N-4080-027 Suppl A&B Rev 0: MSLB Containment P/T

Southern California Edison Company INTERIM CALCULATION CHANGE NOTICE (ICCN)/ CALCULATION CHANGE NOTICE (CCN) COVER PAGE	CALC. NO. N-4080-027	ICCN NO / PRELIM. CCN NO.	N-2	PAGE 1	TOTAL NO. OF PAGES 52
	BASE CALC. REV. 0	UNIT 2 & 3	CCN CONVERSION: CCN NO. CCN- 2	CALC. REV. 0	
	CALCULATION SUBJECT: CONTAINMENT P/T ANALYSIS FOR DESIGN BASIS MSLB - SUPPLEMENT B				
CALCULATION CROSS-INDEX <input checked="" type="checkbox"/> New/Updated index included <input type="checkbox"/> Existing index is complete	ENGINEERING SYSTEM NUMBER / PRIMARY STATION SYSTEM DESIGNATOR 1301 / ABB			Q-CLASS II	
	CONTROLLED PROGRAM OR DATABASE ACCORDING TO SO123-XXIV-5.1	PROGRAM / DATABASE NAME (S) <input checked="" type="checkbox"/> ALSO, LISTED BELOW	VERSION/RELEASE NO.(S)		
1. BRIEF DESCRIPTION OF ICCN / CCN:	<input checked="" type="checkbox"/> PROGRAM <input type="checkbox"/> DATA BASE	NE100 (COPATTA)	G1-15

Add Supplement B to the base calculation.

Calc No. <u>N-4080-027</u>	DCP/FIDCN/ FCN No. & Rev. <u>N/A</u>	CCN CONVERSION: CCN NO. CCN- <u>2</u>
Subject: <u>CONTAINMENT P/T ANALYSIS FOR DESIGN BASIS MSLB - SUPPLEMENT B</u> Sheet <u>B1</u> of <u> </u>		
Sy

FIGURE 2-5: ENERGY
 MSLB 102% POWER, 7.48 FT² BREAK AREA
 VAPOR --- SUMP --- TOTAL --- HEAT SINKS

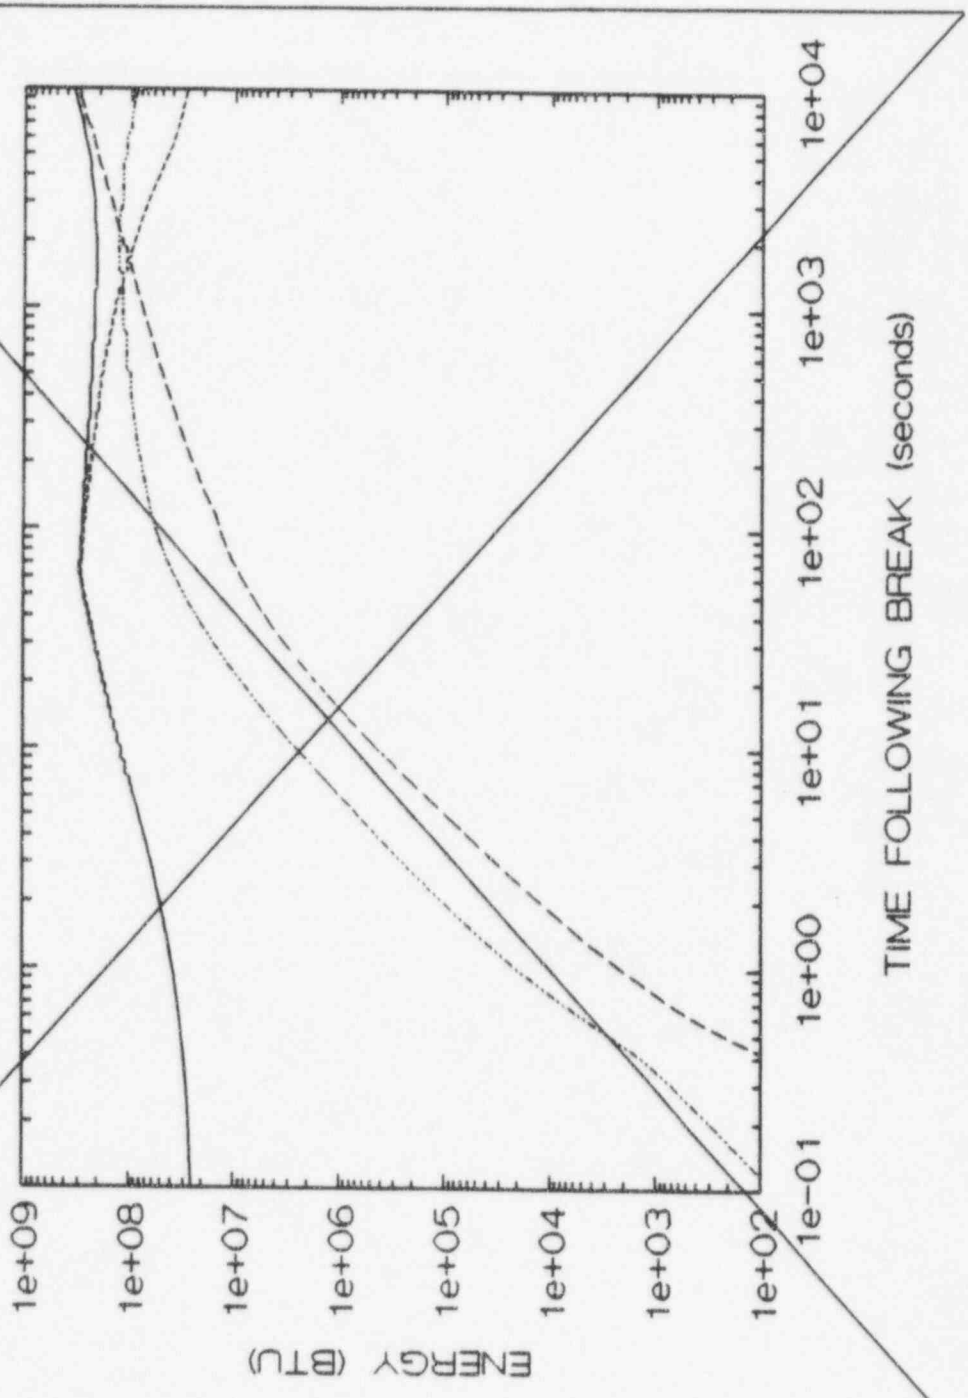
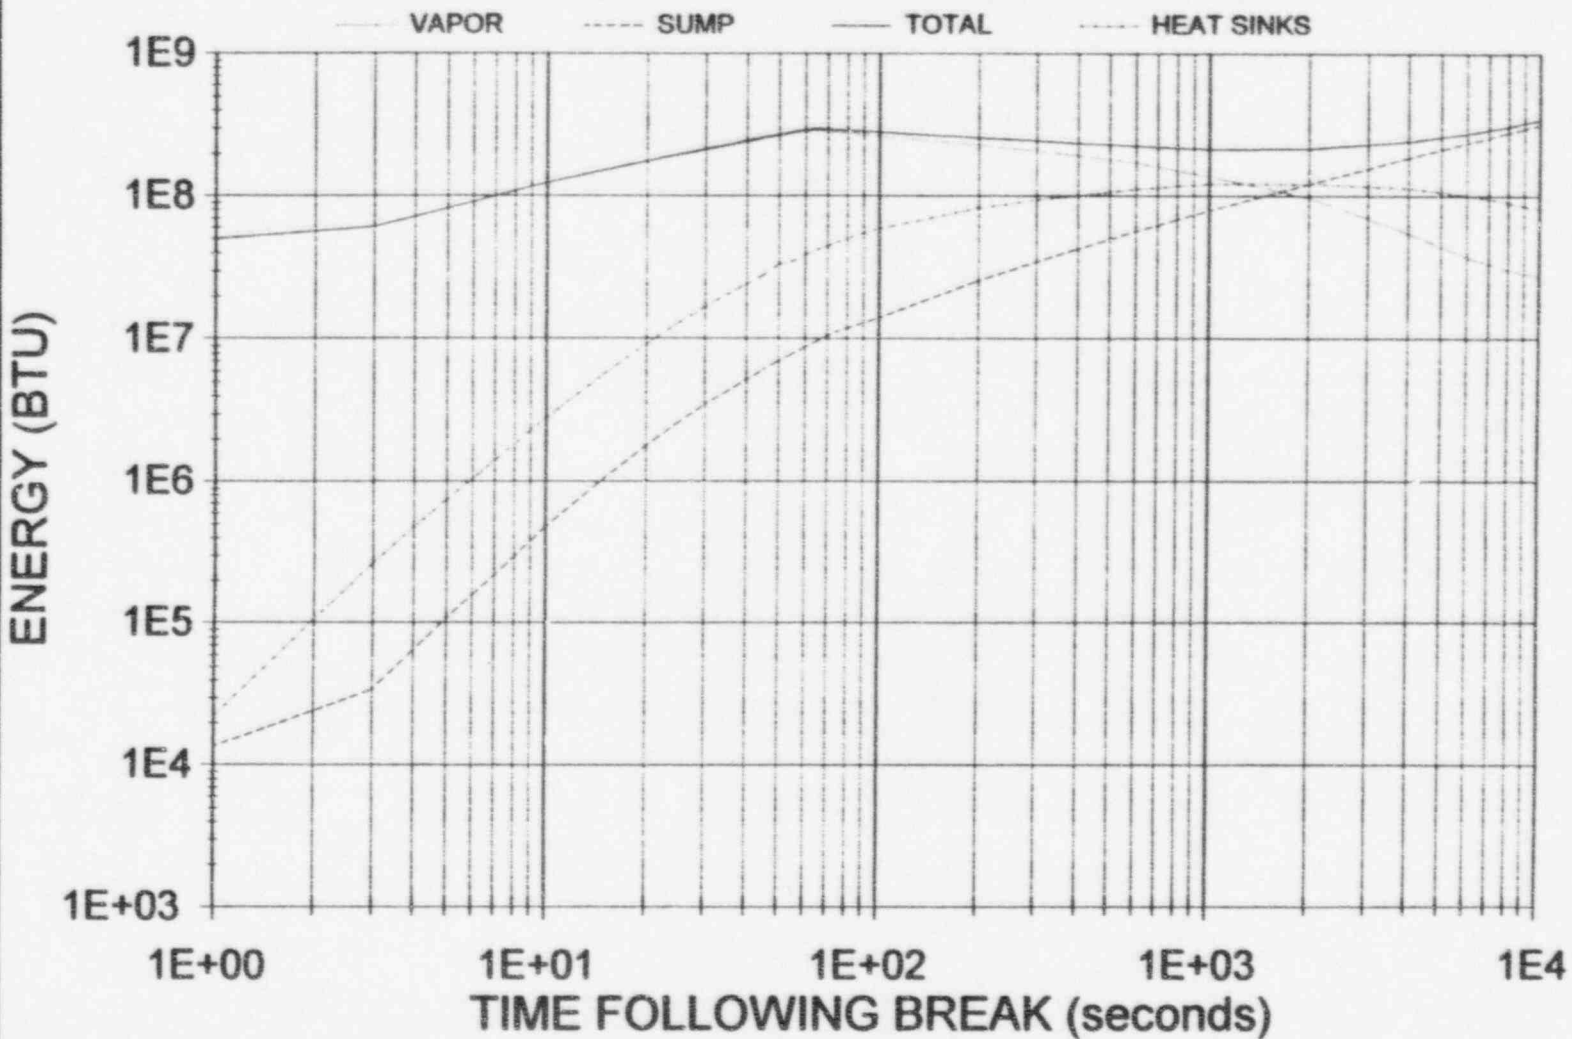
THIS FIGURE IS REPLACED BY FIGURE 2-5 IN SUPPLEMENT B | △

Figure 2-5 presents the integrated energy transferred from the containment vapor region by one train of air coolers, two Emergency Cooling Units (2ECUs) and one train of containment spray as a function of time. The plots in Figure 2.4 are generated using the data presented in Section 10.2. The ECUs transfer vapor energy to the component cooling water system (CCWS) which transports the energy outside the containment. The containment sprays are operating in the injection mode and transfer vapor energy to the containment sump region as hot water.

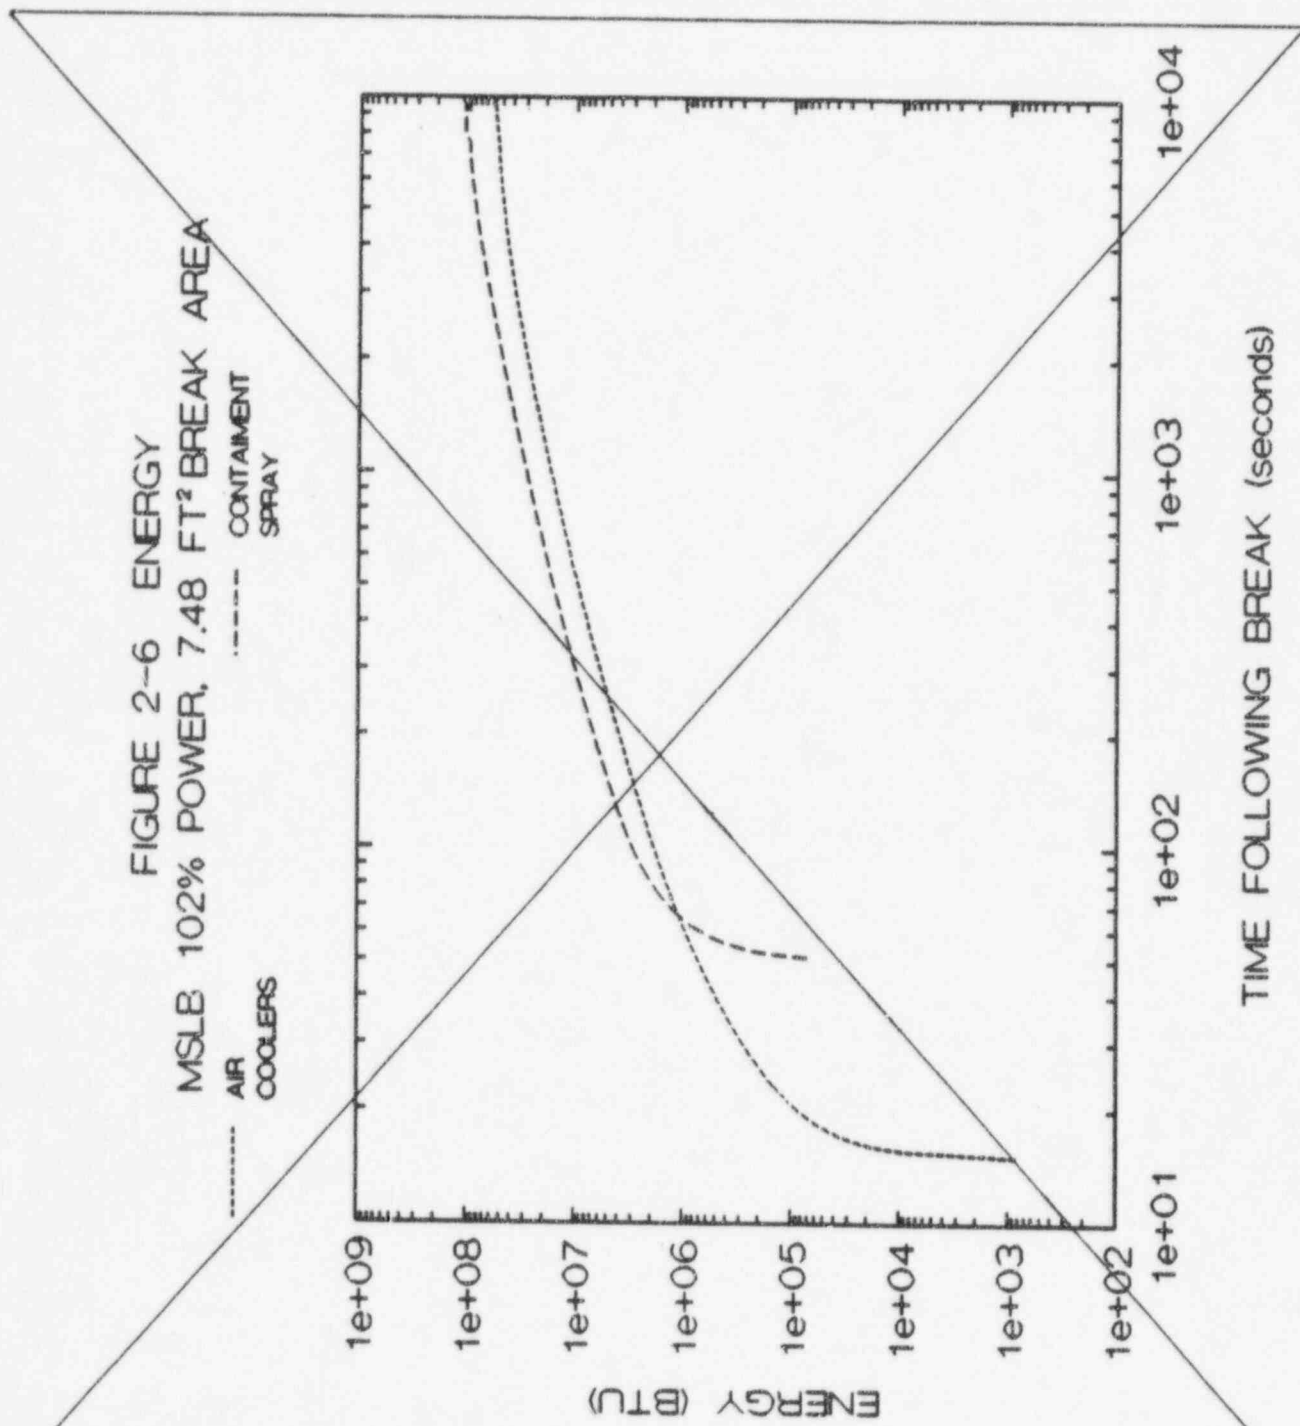
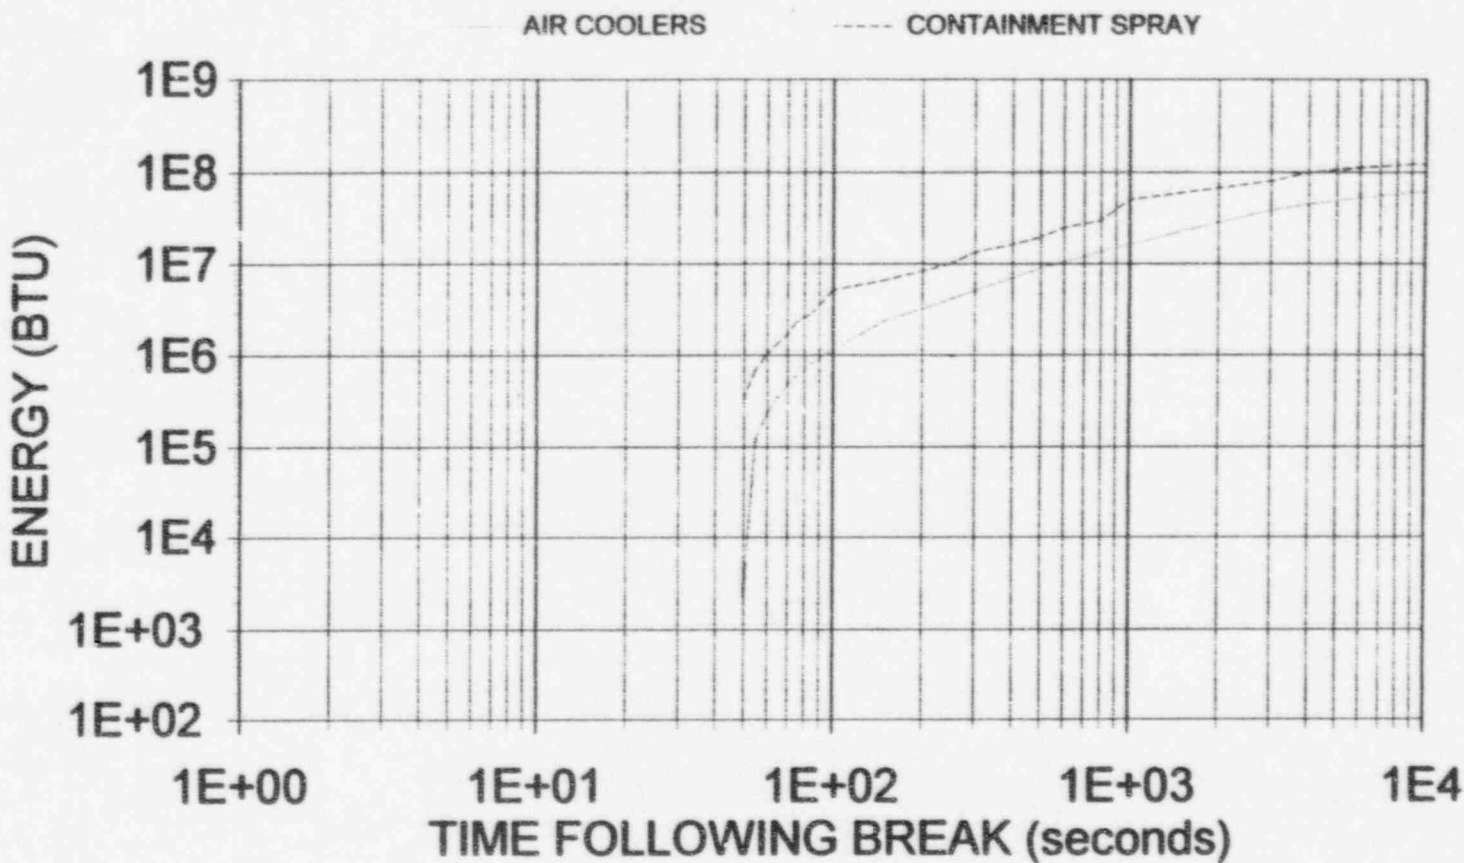
THIS FIGURE IS REPLACED BY FIGURE 2-6 IN SUPPLEMENT B

Figure 2-6 presents the integrated heat transfer of the air coolers and containment sprays. The plots presented in Figure 2.6 are generated using the data tabulated in Section 10.2
